IT\_LT\_1223\_094

**RE: Comments on Klamath Facilities Removal Draft Environmental Impact Statement/Environmental Impact Report**

The Karuk Tribe appreciates the opportunity to comment on the Draft Environmental Impact Statement/Environmental Impact Report (DEIS/DEIR) for Klamath Facilities Removal, released September 21, 2011, as a joint environmental document for compliance with the National Environmental Policy Act (NEPA) and California Environmental Quality Act (CEQA).

**Page 3.2-67:**

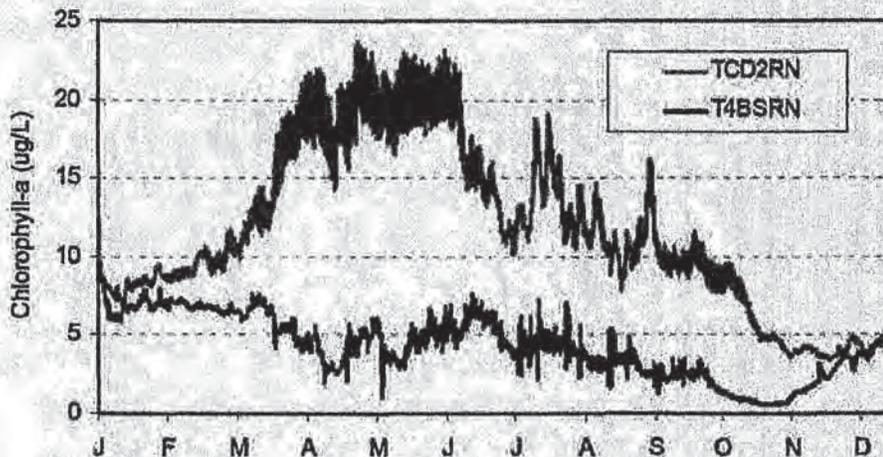
*"Continued impoundment of water at the Four Facilities could result in long-term seasonal and daily variability in pH in the Klamath River downstream of Iron Gate Dam."*

There is inconsistency regarding the pH issue in the DEIS/DEIR. In some sections, it is stated that the Proposed Action will increase pH below Iron Gate Dam, whereas in other places it is stated that it will decrease. We have researched the available information regarding this topic, and the evidence is confusing and unclear. On one hand, existing monitoring data from continuously recording pH probes indicate that pH during the summer is often higher, but not always, at Iron Gate than at sites downstream such as Seiad Valley (for example, see the 2000-2004, 2005, and 2007 data presented on pages C-47 to C-50 of the DEIS/DEIR appendix C). Additional pH data are available in the Karuk Tribe's 2008 water quality report (Karuk Tribe 2009) and the upcoming Klamath Hydroelectric Settlement Monitoring 2010 report (currently in draft). Additionally, as noted in comments regarding page 3.2-113 below, pH values in the surface of the reservoirs are extremely high (though they are less high at the ~5 m depth from

However, the TMDL model predicts that for the dams-in TMDL-compliance scenarios (T4BSRN)(used in the DEIS/DEIR to approximate the No Action/No Project Alternative), mid-summer pH would be extremely low (i.e. near 8.0 with almost no daily fluctuation), whereas mid-summer pH under the dams-out scenario (TCD2RN)(used in the DEIS/DEIR to approximate the Proposed Action), would range from 8.5-9.0(see Figure 3.2-24).

**Page 3.2-77:**

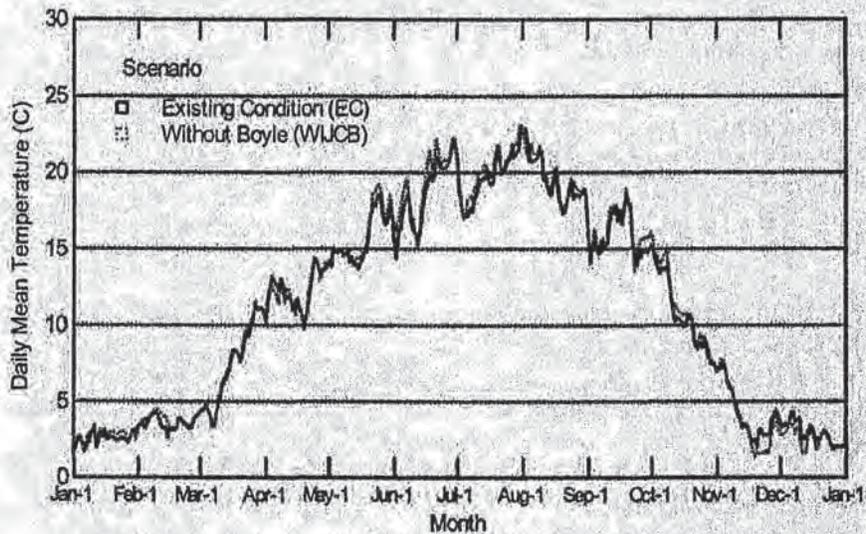
This page contains several sentences referenced to Asarian and Kann (2006a), however the information is not actually stated in the text of the cited report (which focused on nutrients, not temperature), but rather is derived from graphs created from PacifiCorp's water quality model outputs that are included as an electronic appendix to that report. The references should be clarified stating, instead, "data from electronic appendices of Asarian and Kann 2006a".

Here are the three sentences referenced to Asarian and Kann (2006a), with some suggested revisions:

1) "Higher daily fluctuations would also occur in the J.C. Boyle bypass reach because it would no longer be dominated by cold groundwater inputs at a relatively constant temperature of 11-12 C (Kirk et al. 2010, Asarian and Kann 2006a)" suggested revision: change citation to just "(Kirk et al. 2010)" (not necessary to cite Asarian and Kann 2006a).

2) "In the J.C. Boyle peaking reach model results indicate that water temperatures under the Proposed Action would be slightly lower (0.5-1 C [0.9-1.8 F]) than those predicted under the No Action/No Project and would exhibit lower daily fluctuation during June through September (NCRWQCB 2010a, Asarian and Kann 2006a)." The DEIS/DEIR Figure 3.2-3 shows water temperatures at Stateline in the peaking reach and does not indicate a consistent slightly lower overall (i.e. mean) temperature except in October and November, though it does indicate reduced daily fluctuations, i.e. lower maximum and higher minimum temperatures. Modeled mean temperatures are actually very similar between the two scenarios, with the No Action/No Project being generally very slightly lower (<0.5 C) in June - September, as illustrated in the following figure (generated from the data in the Asarian and Kann 2006a electronic appendix):

This is confusing. What is meant by "In the Klamath River downstream of the J.C. Boyle bypass and peaking reaches..."? Stateline (the location shown in cited Figure 3.2-3) is in the Peaking Reach. This should be clarified. Model results from Stateline would be a good approximation for the whole peaking reach (from the Boyle Powerhouse down to the upper end of Copco Reservoir) but the difference in temperature between the scenarios will be quite different between Stateline and downstream at Copco Dam and Iron Gate Dam due to the thermal mass of the reservoirs. For Copco Dam and Iron Gate Dam, it would be much better to use Figure 3.2-4 or Figure 3.2-5. Again, the citation of Asarian and Kann (2006a) is not necessary here.

The suggested revision is: "In the J.C. Boyle peaking reach model results indicate that water temperatures under the Proposed Action have lower daily maximums (0.0-2 C [0.0-3.6 F]) than those predicted under the No Action/No Project and would exhibit lower daily fluctuation during June through September (NCRWQCB 2010a) (Figure 3.2-3)."

**Page 3.2-104:**

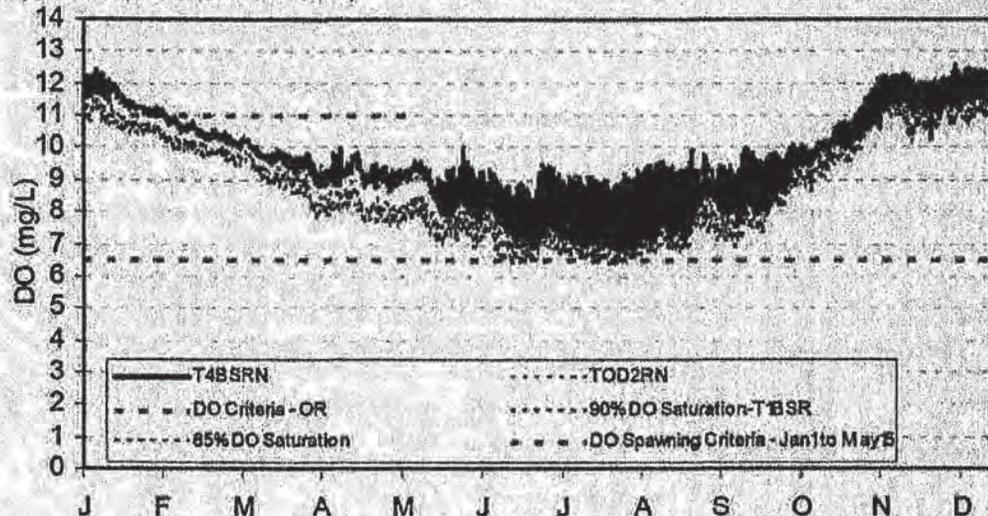
*"The Klamath TMDL model (see Appendix D) also predicts that daily fluctuations in dissolved oxygen at these locations during this same period may be greater under the Proposed Action (TCD2RN) than the No Action/No Project Alternative (T4BSRN), a condition potentially linked to greater periphyton biomass and associated daily photosynthetic swings in oxygen production in the free flowing river."*

That sentence is an incorrect summarization of the model results, because while the statement is correct for the below J.C. Boyle Dam site, it is incorrect for Stateline. The model predicts the opposite for Stateline: daily fluctuations are less under the Proposed Action (TCD2RN) than the No Action/No Project Alternative (T4BSRN). The figure presented in the DEIS/DEIR for Stateline D.O. is somewhat blurry. The following extraction of the TMDL figure (from NCRWQCB 2010a Appendix 7) shows it more clearly:

Interestingly, the TMDL model does predict increased periphyton biomass for the Proposed Action (TCD2RN), presumably due to slightly less trapping of nutrients and organic matter in J.C. Boyle Reservoir under a free-flowing condition. Thus, the prediction of decreased D.O. fluctuations under the Proposed Action (TCD2RN) is likely due to the lack of hydropower

In summary, the suggested revision for the sentence quote above is: "The Klamath TMDL model (see Appendix D) predicts that daily fluctuations in dissolved oxygen directly downstream of J.C. Boyle Dam would be larger during this same period under the Proposed Action (TCD2RN) than the No Action/No Project Alternative (T4BSRN) (Figure 3.2-16), presumably due to the removal of the reservoir. In contrast, the TMDL model predicts reduced daily fluctuations in dissolved oxygen at Stateline in the peaking reach under the Proposed Action (TCD2RN) than the No Action/No Project Alternative (T4BSRN) (Figure 3.2-16), likely due to the lack of hydropower peaking."

**Page 3.2-113:**

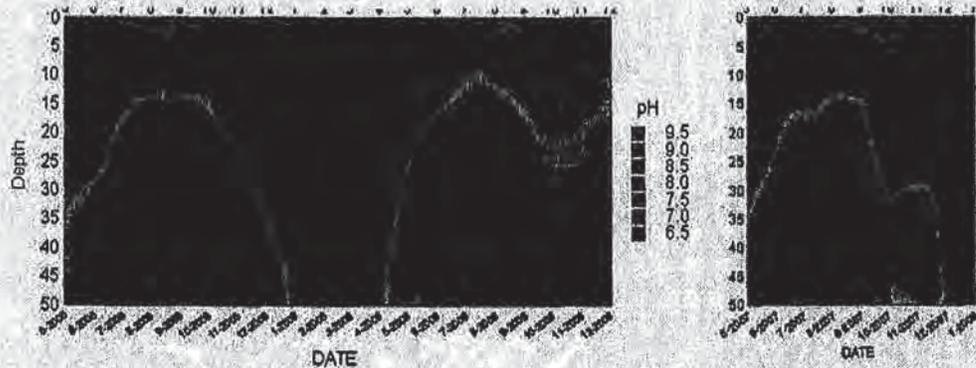
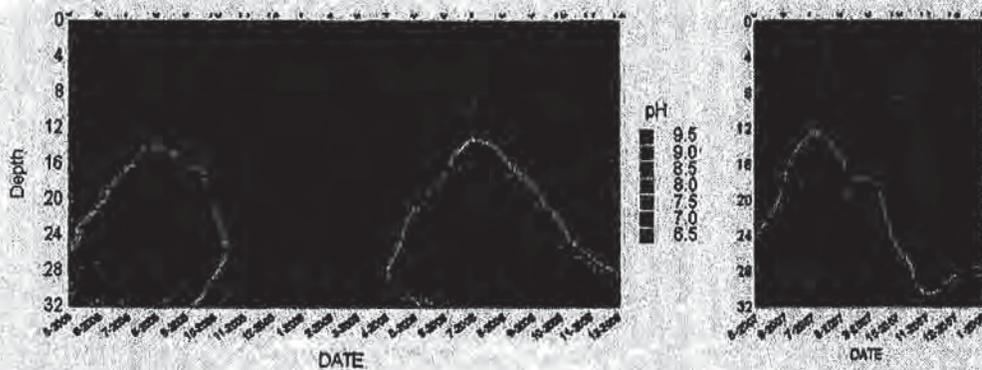
The discussion of how the Proposed Action would affect pH in the Upper Klamath Basin and the Hydroelectric Reach is incomplete and misses the "big picture" because it is all about how pH will change in the reaches that are *current free-flowing river reaches*. There is no explicit discussion of how pH will change in the reaches *that are currently reservoirs*. In our opinion, this is just as important and worthy of mention. Dam removal would eliminate the extremely high pH that occurs in the surface waters of the Iron Gate and Copco Reservoirs during peak summer blooms. We recommend that a discussion of this topic be added. Information about high pH in the reservoirs can be found in Asarian et al. (2009) and in PacifiCorp's annual water quality monitoring reports by Raymond (various years). For example, Figure 7 in Asarian et al. (2009) shows pH >9 at the surface of Iron Gate Reservoir (note: variation in the time of day that measurements were taken confounds detailed interpretation; however, the data do document the presence of very high pH):

Figure 6 in Asarian et al. (2009) shows pH >9 at the surface of Copco Reservoir:
